RE: Response to ACEH November 17, 2014 Correspondence
Former Chevron Asphalt Plant and Bulk Terminal #20-6265
1520 Powell Street, Emeryville, California
Case Number: *RO0002535*

Response to ACEH November 17, 2014 Correspondence
Former Chevron Asphalt Batch Plant and Bulk Terminal #20-6265
1520 Powell Street
Emeryville, California
Case Number: RO0002535

ACEH comments contained in the November 17, 2014 correspondence are presented below in italicized text, with the responses provided in plain text.

FORMER CHEVRON ASPHALT TERMINAL 206265 1520 POWELL STREET EMERYVILLE, CA	
SITE PLAN	
	FIGURE 3

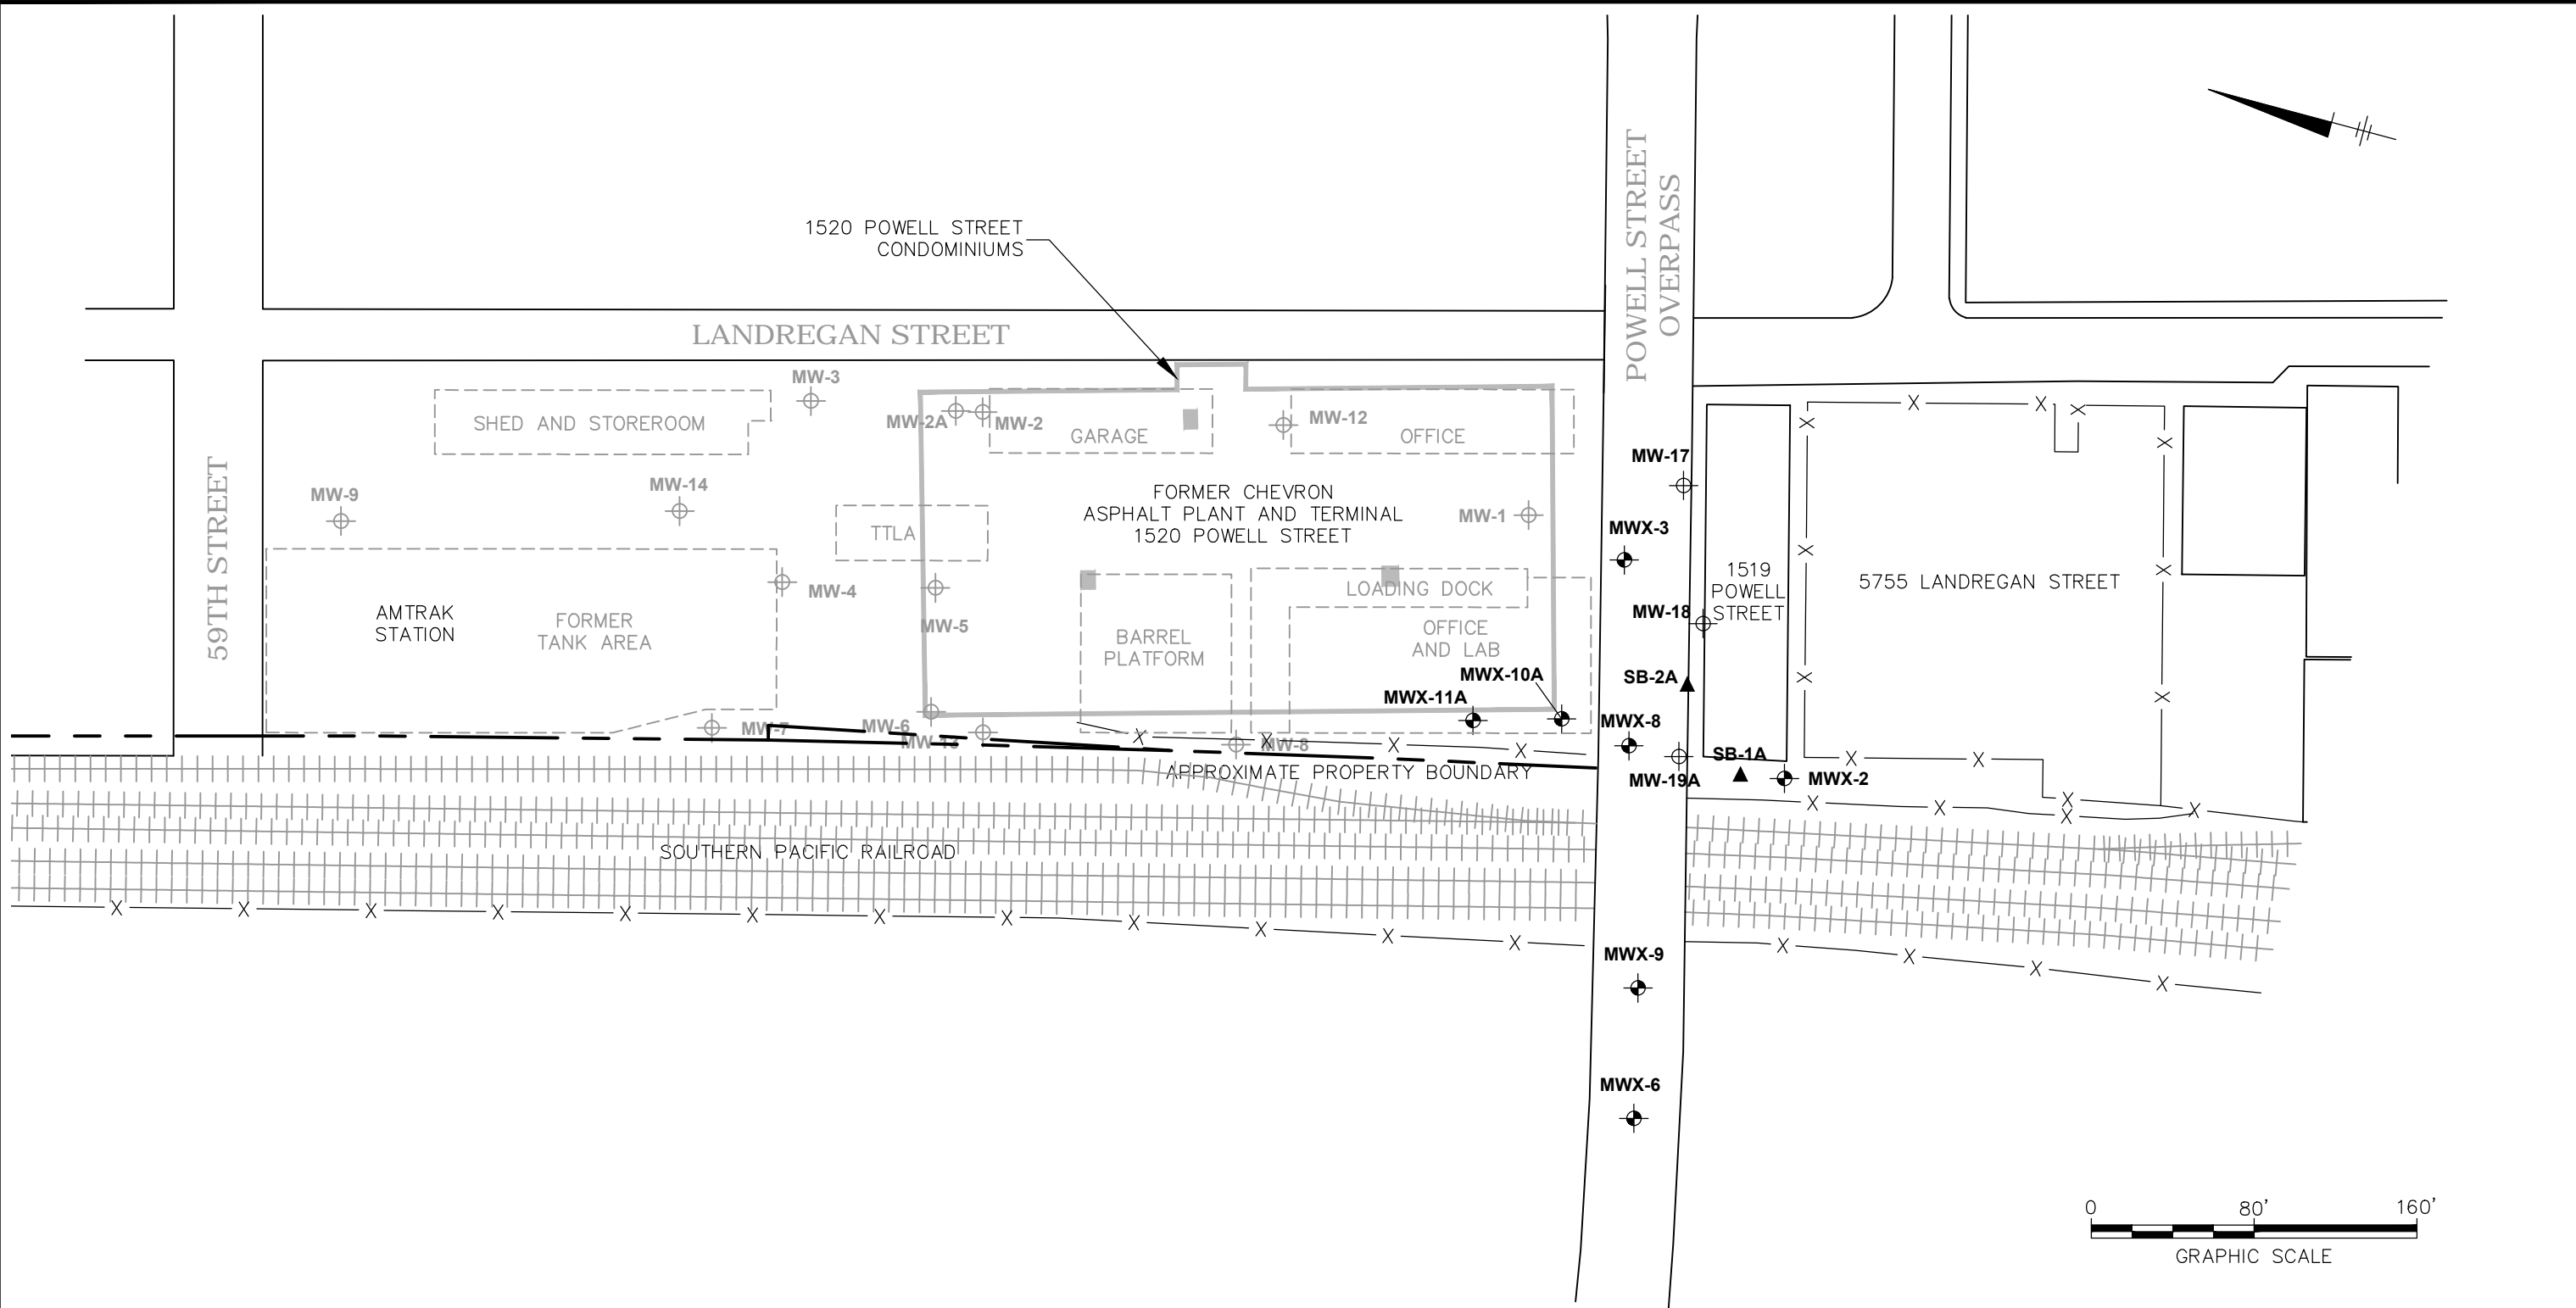
Risk of Vapor Intrusion – The Arcadis document determined the location of three elevator pits associated with the existing site building, and notified ACEH that groundwater infiltration has not occurred in the past four years into the elevator sumps at these locations. Although it does not currently appear viable to obtain a groundwater infiltration sample, ACEH remains concerned that at least one elevator shaft can function as a preferential pathway for vapor intrusion, and that apparently unexcavated onsite shallow TCE soil contamination outside the building envelope, commented in Technical Comment 4 above, remains as a vapor intrusion risk. Please be aware that waterproofing membranes have not been documented to withstand HVOC contamination. Additionally, while high capacity fans are reported to be linked to a carbon monoxide detector in the basement, the linkage of the carbon monoxide detector with respect to the mitigation of potential chlorinated solvent vapor intrusion has not been established. This potential vapor risk should be incorporated into the SCM.

As mentioned in the response to Comment 1a, ARCADIS proposes to collect vapor samples from within each of the three elevator shaft sump areas to determine if there is a vapor intrusion risk associated with any residual COCs [trichloroethene (TCE), tetrachloroethene (PCE), cis-1,2-dichloroethene (cis-1,2-DCE), trans-1,2-DCE, and vinyl chloride in site soil or groundwater.

The following samples will be collected to determine the potential for vapor intrusion through the elevator shaft pathway (elevator shaft locations are shown on Attachment 2):

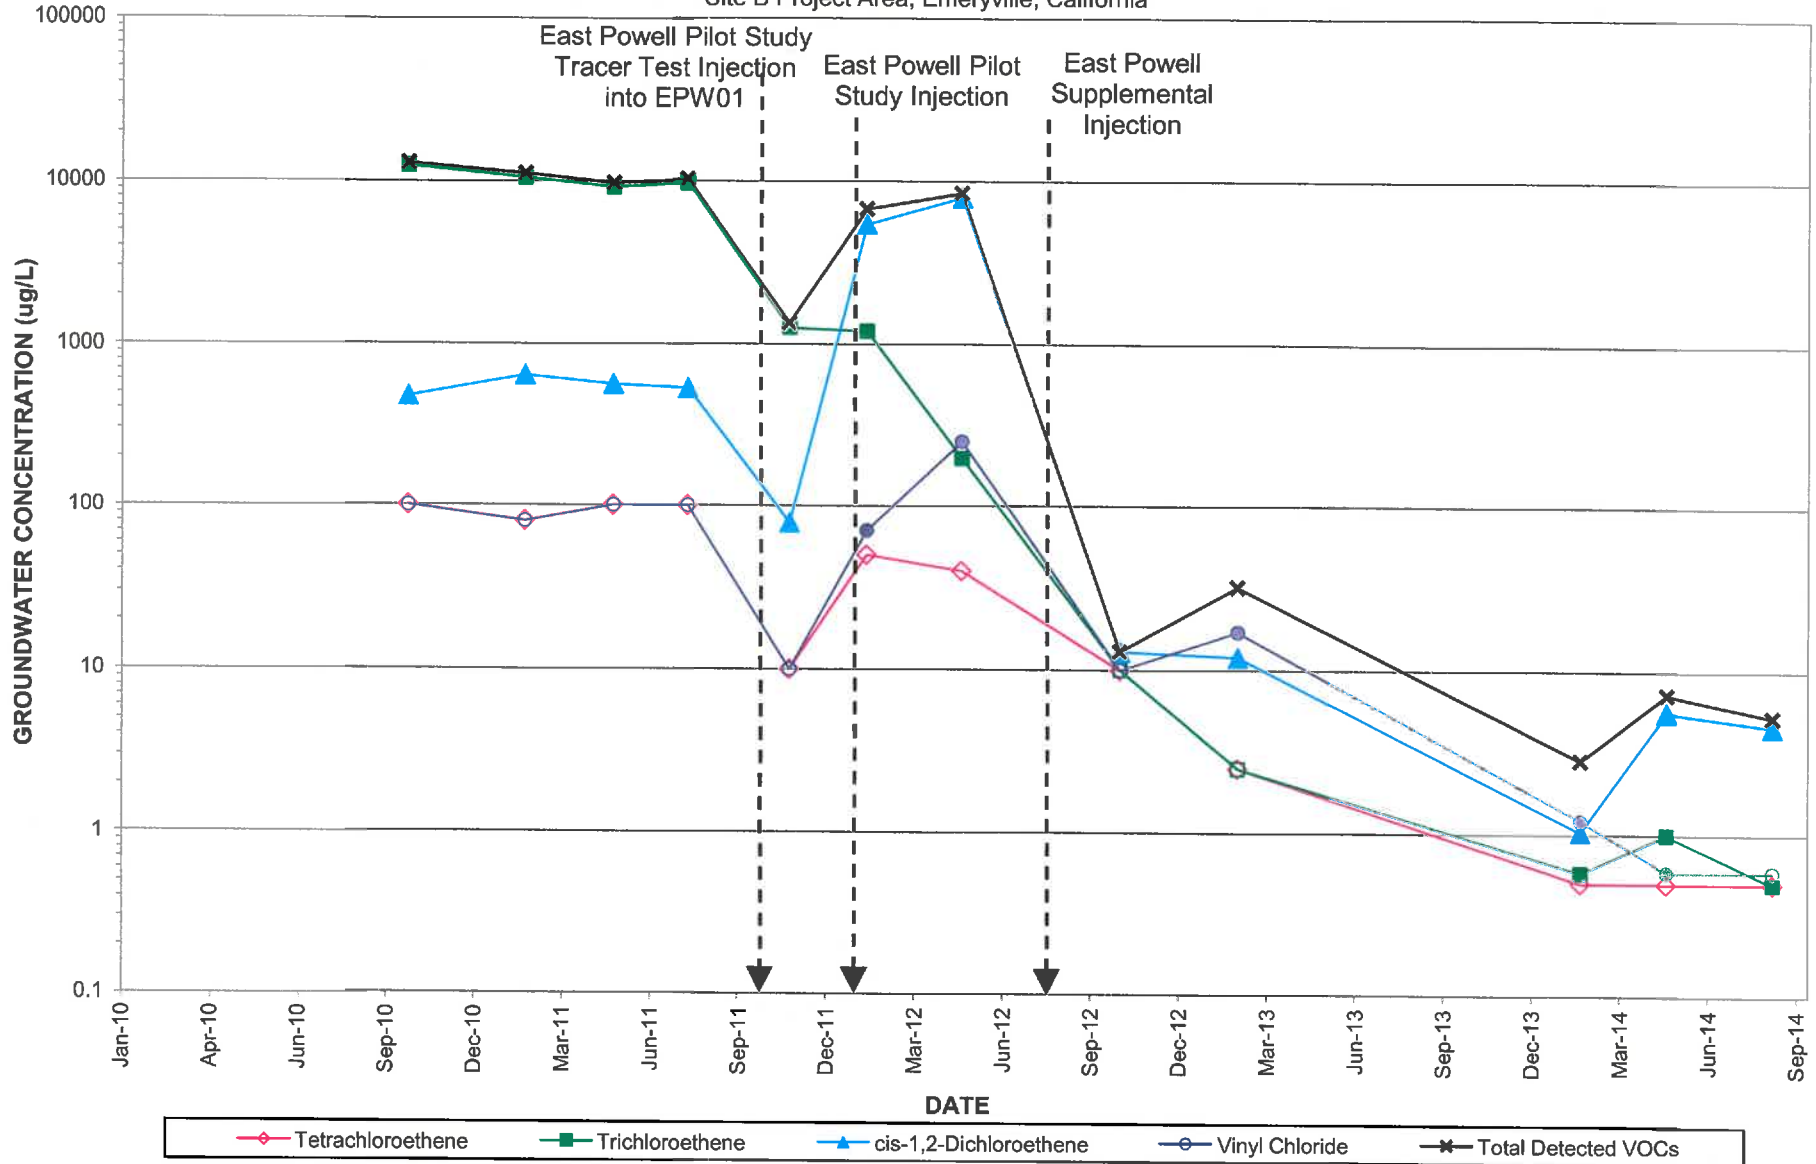
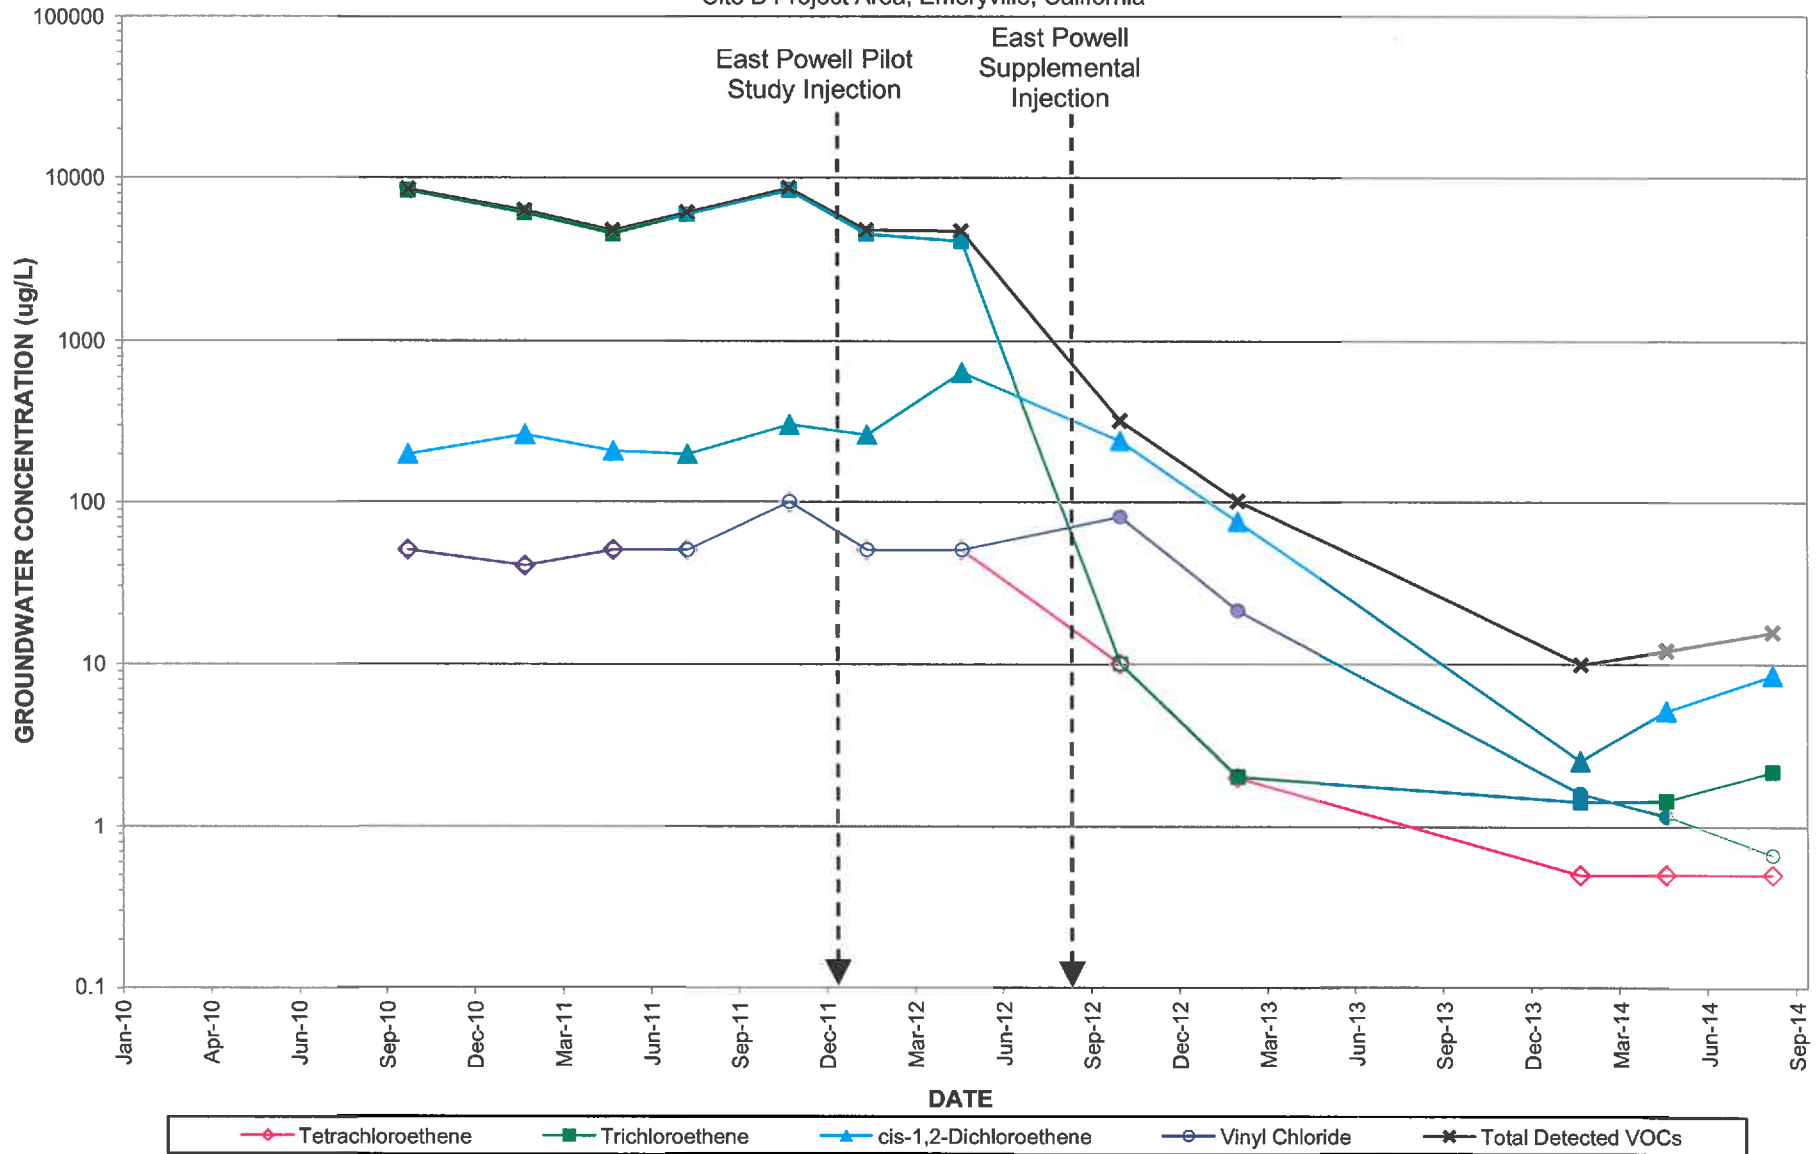
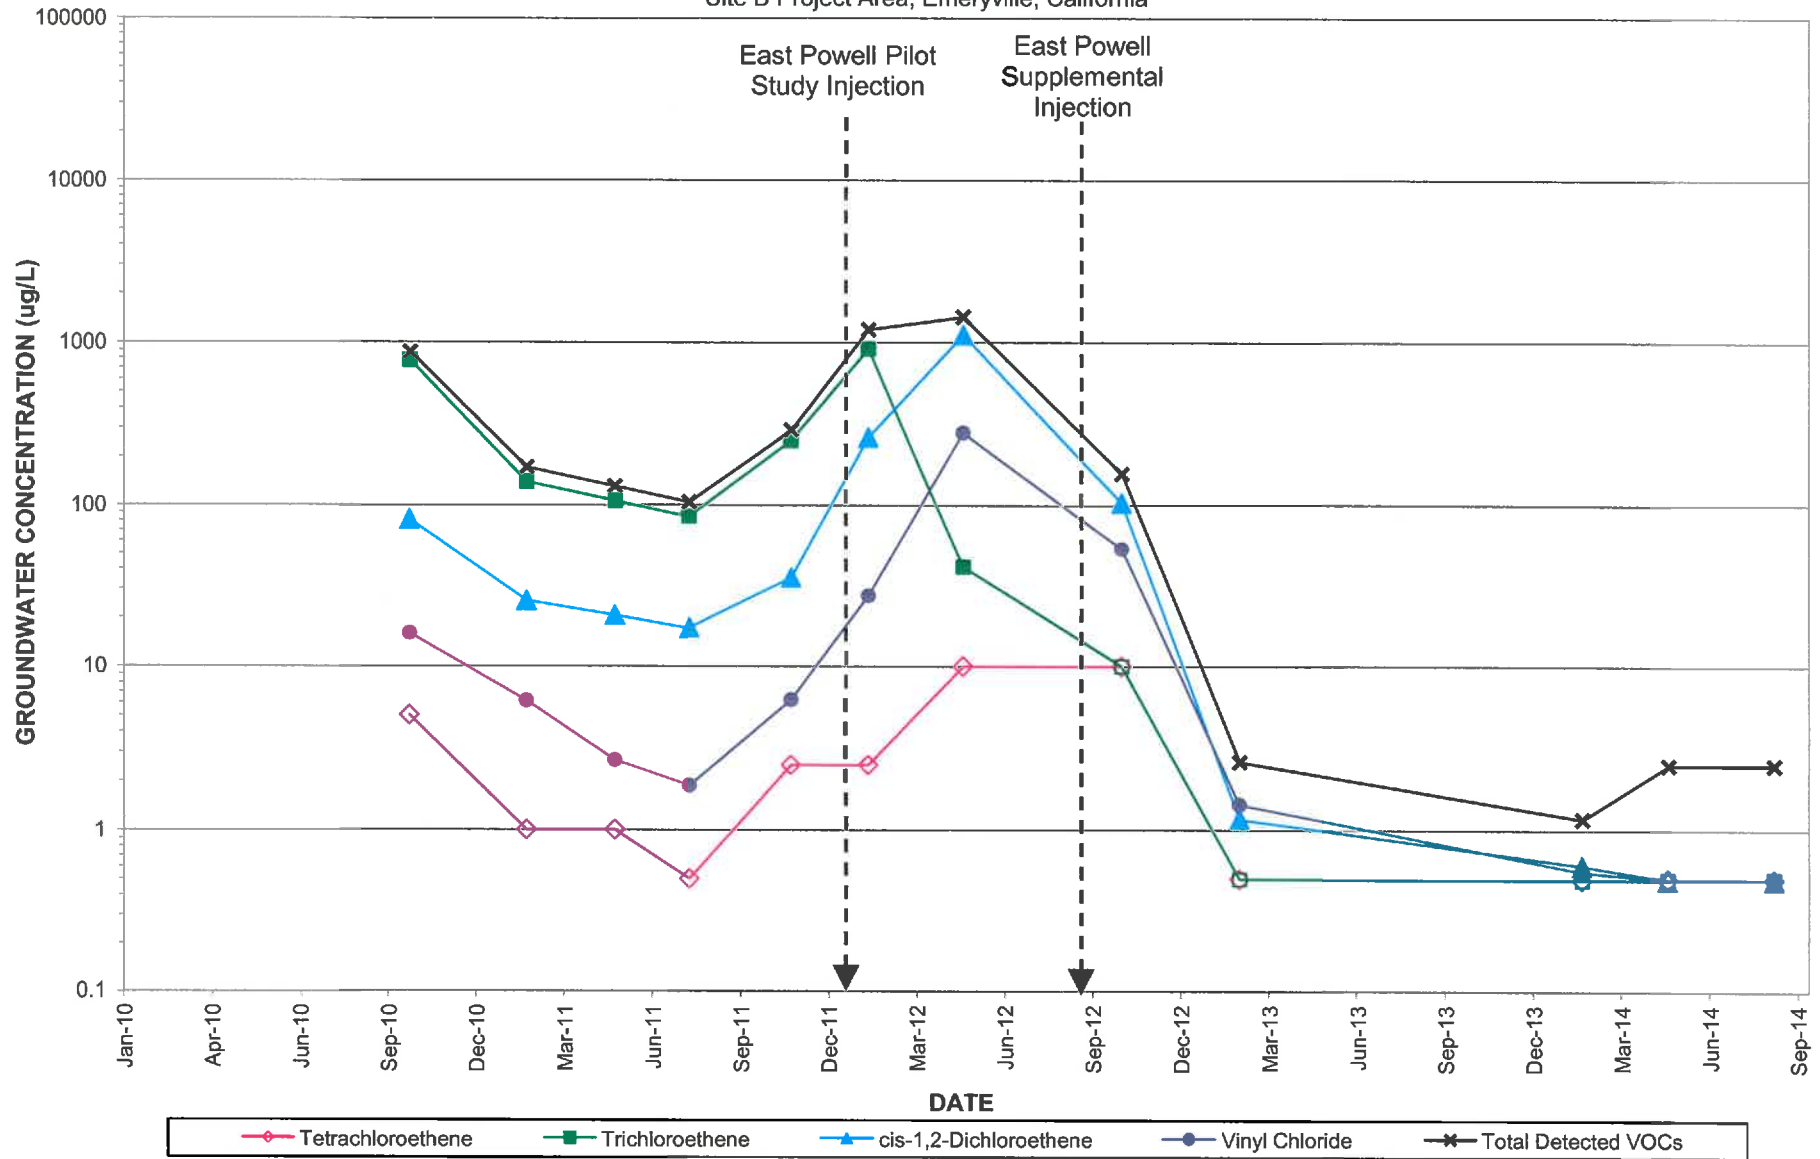
Source of TCE - *Prior to the injection of EVO beneath Powell Street for the City of Emeryville, concentrations of TCE up to 2,100 micrograms per liter ($\mu\text{g/l}$) TCE and*

12,400 µg/l were documented in the upper CGU and lower CGU, respectively. PCE was generally not detected, except along the southern margin of Powell Street, as discussed above. Since injection of the EVO, groundwater contaminant concentrations in wells in the Powell Street vicinity, including EPW01 to EPW04, and EPW06, document significant reductions of all HVOCs; however, have not been sampled since December 2012 or February 2013, depending on the well set.

A review of the EKI *Site B Project Area Final Third Quarter 2014 Groundwater Monitoring Report*¹ indicates that TCE groundwater sample concentrations in downgradient monitoring wells have decreased to non-detect concentrations (<0.5 µg/l) in monitoring wells EPW01 and EPW04 and to concentrations just above laboratory reporting limits (2.15 µg/l) in EPW02. TCE concentrations in the EPW wells have decreased substantially since the final EVO injection activity in August 2012 and do not appear to be rebounding. Monitoring well EPW01, EPW02, and EPW04 analytical results, concentration trends, and a well location figure are included as Attachment B. The decrease of TCE concentrations in the monitoring wells within the

Powell Street site indicates that there currently is no longer a significant upgradient source of TCE and remediation of the former Chevron site is not necessary.

As discussed in the above Response 1c, concentrations in the downgradient EPW monitoring wells have decreased significantly since the implementation of the EVO remedial activity. Historically, the groundwater concentrations detected in samples collected from the EPW wells (screened in the deep Upper GCU) have been consistently higher than the concentrations detected in the samples collected from the former Chevron site monitoring wells (screened in the shallow Upper GCU). An evaluation of the TCE groundwater results from the EPW monitoring wells during the

most recent sampling event (third quarter 2014) indicate that TCE groundwater sample concentrations in downgradient monitoring wells have decreased to non-detect in monitoring wells EPW01 and EPW04 and to concentrations just above laboratory reporting limits in EPW02. The third quarter 2014 event occurred two years after the last EVO remedial activity. These recent EPW groundwater monitoring results further indicates that the current groundwater concentrations in the monitoring wells associated with the former Chevron site would also have similar concentrations (non-detect to slightly above laboratory detection limits). Therefore, additional groundwater monitoring activities at the former Chevron site would be not be beneficial.
